Re: Amendment to Permit to Construct a Warehouse Annex Building, Add a Fan and Extend the Existing Fan Pad, Sufco Mine, C/041/002

Permittee: Canyon Fuel Company, LLC
Mine: Sufco Mine **Permit Number:** C/041/0002
Title: Revisions to Permit to Construct a Warehouse Annex Building and Add a Fan and Extend the Existing Pad
Description, Include reason for application and timing required to implement:

APPLICATION FOR COAL PERMIT PROCESSING
Detailed Schedule Of Changes to the Mining And Reclamation Plan

SCALE:	DATE:	DRAWN BY:	ENGINEER:	SHEET NO.
1" = 50'	12/17/91	SWF\TRB	RBW	PLATE 5-2Av20
CHECKED BY: VSB	FILE NAME: H:\DRAWINGS\MRP\PLATES\PLATE 5-2Av20.dwg

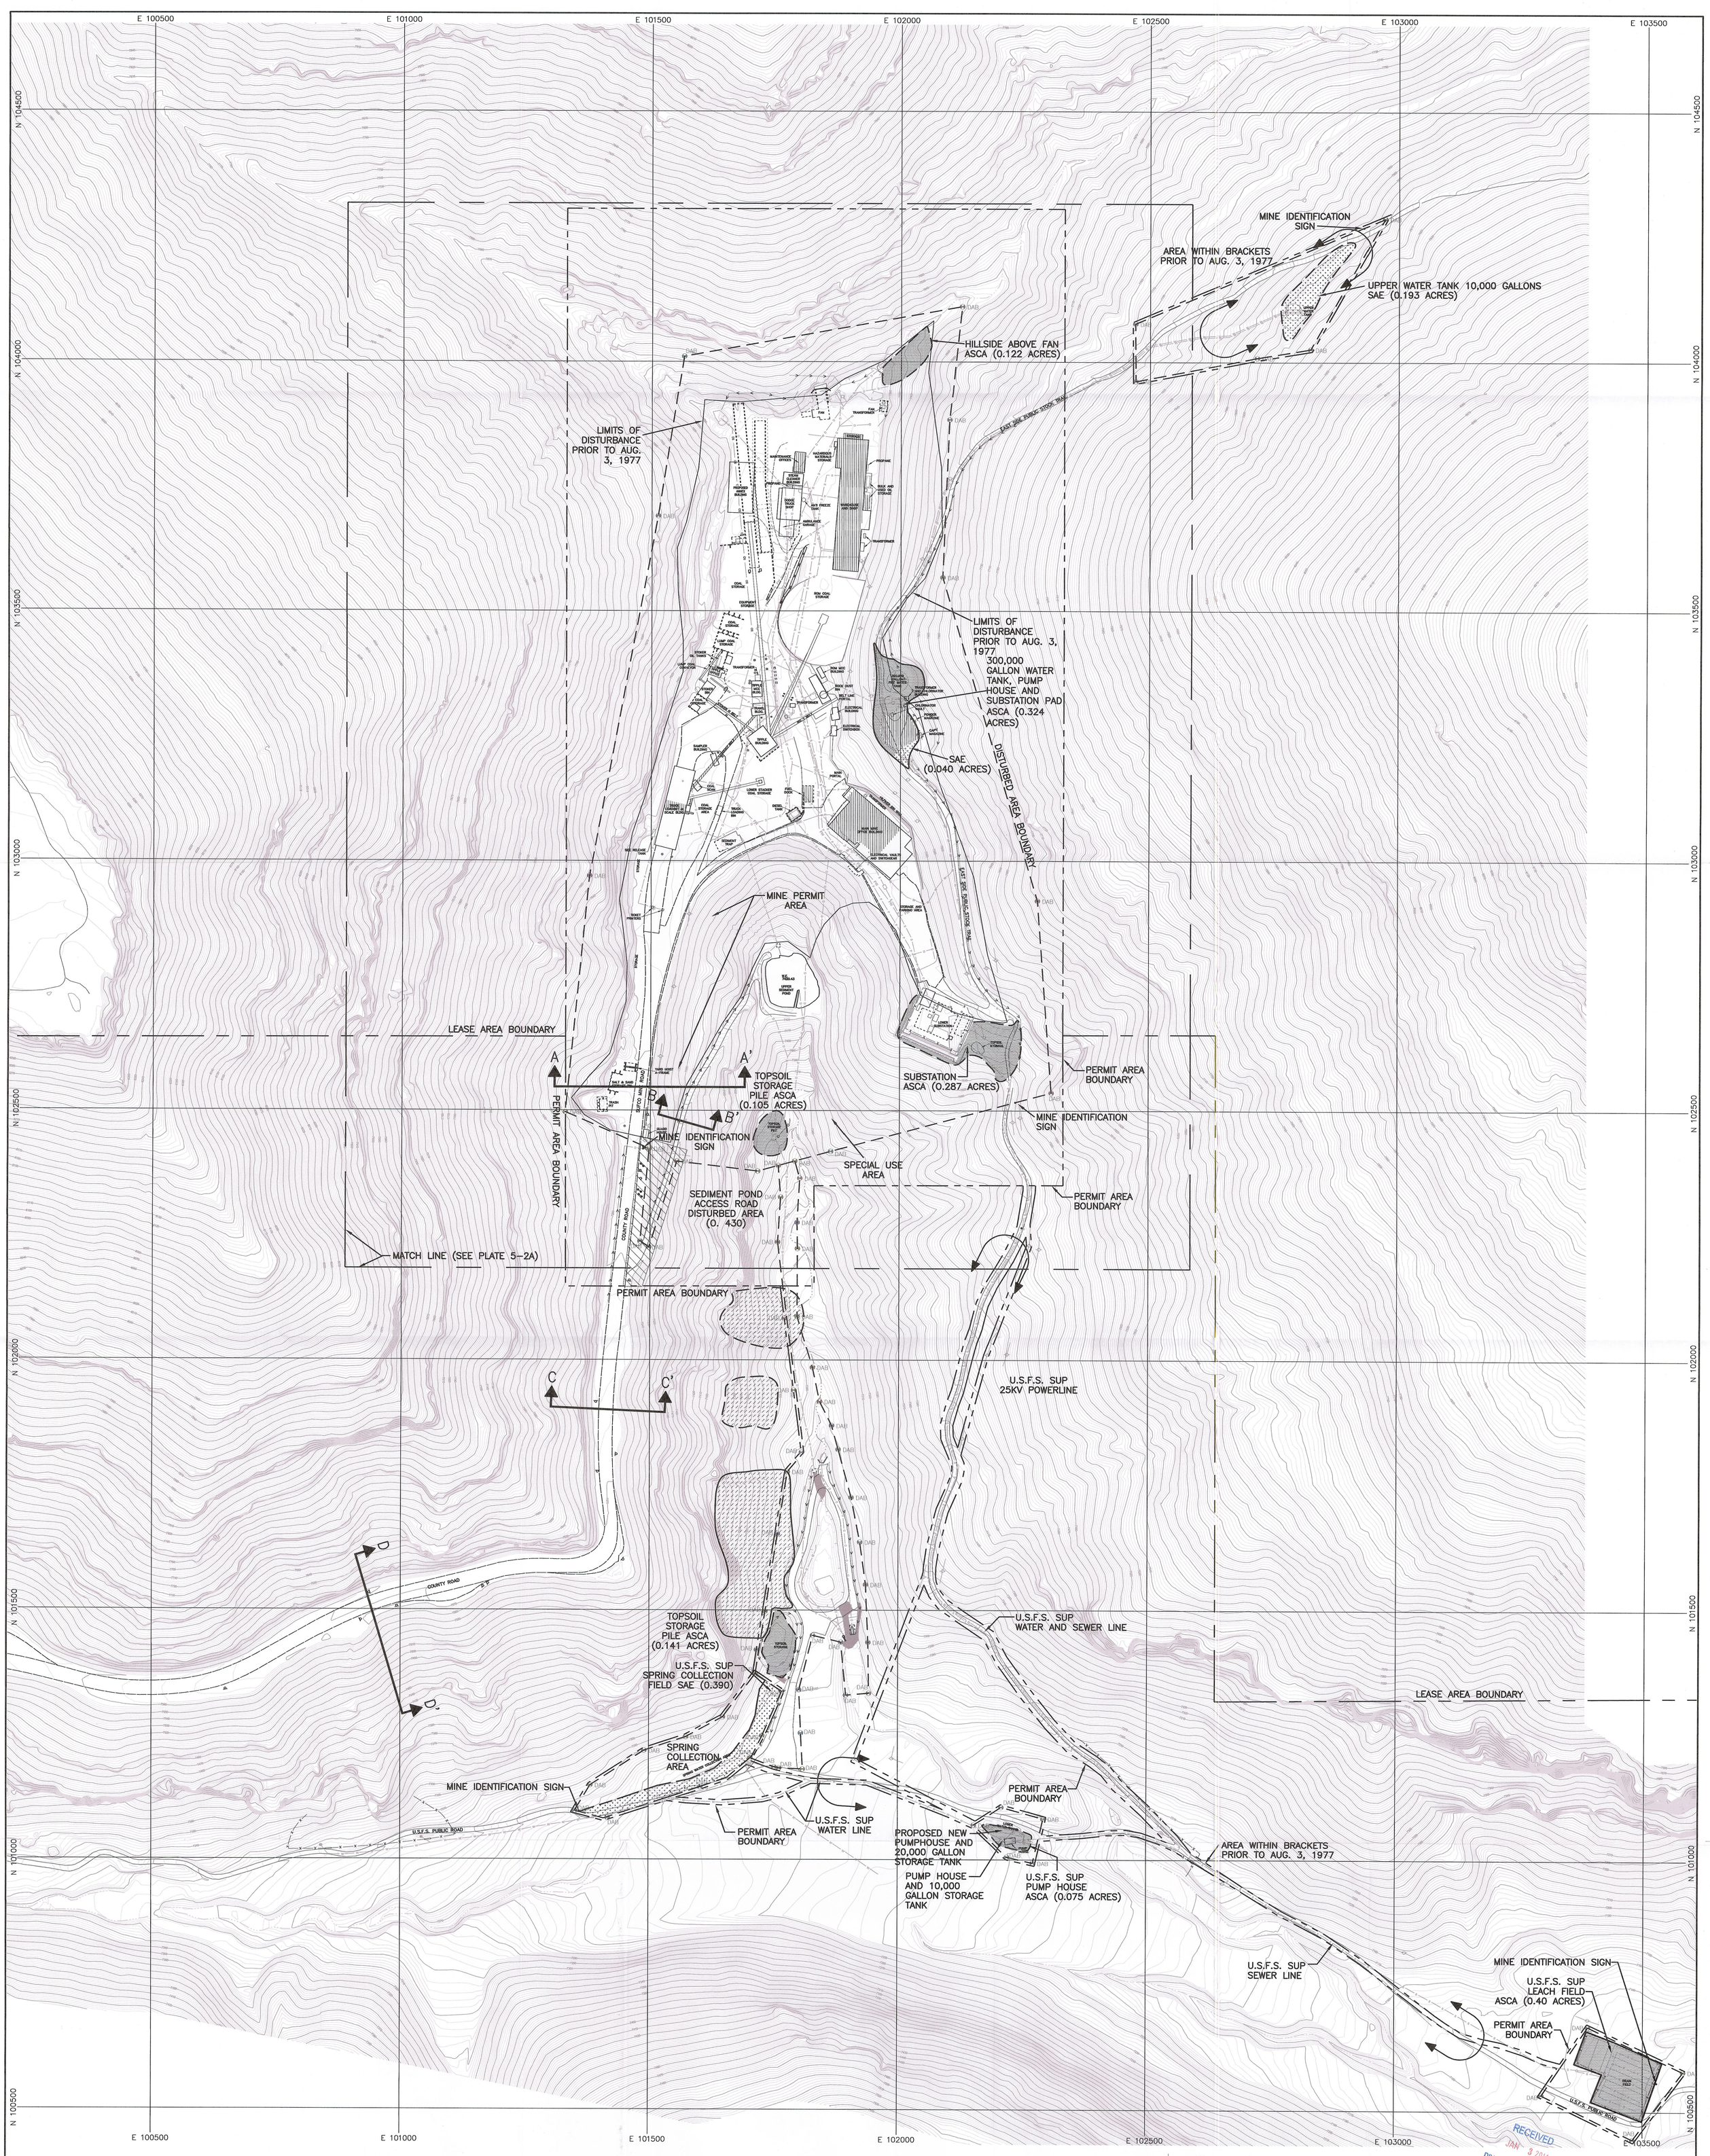
Please find enclosed with this letter two copies of an amendment to address the construction of a warehouse building to be used for the storage of parts and supplies. The building will be constructed within the existing disturbed area boundary. The location of the proposed building is on disturbed sub-soils and drainage controls are in-place for the area. Refer to Plates 5-2A and 5-2B for the location of the proposed building.

The Warehouse Annex building will be constructed in an area which has existing drainage controls and the soil have been pre-disturbed (Plate 5-2A & 5-2B). The area will be leveled to allow access to the building by small equipment and delivery trucks.

NO.	DATE	REQ. BY	DWG. BY	REMARKS
15	JULY 24, 2009	MLD	KBB	
16	JUNE 3, 2010	FLR	KBB	ADDED MINE 2 PORTALS AND DRAINAGE
17	AUG. 6, 2010	FLR	KBB	ADDED SAND & SALT BIN, LUMP BIN & CONV.
18	JULY 22, 2011	MLD	KBB	ADDED YARD HOIST, SALT & SAND BIN
19	AUG. 07, 2013	MLD	TRB	ADDED WEST LEASE PORTAL & BELTLINE
20	DEC. 11, 2013	VLM	TRB	ADDED ANNEX BUILDING
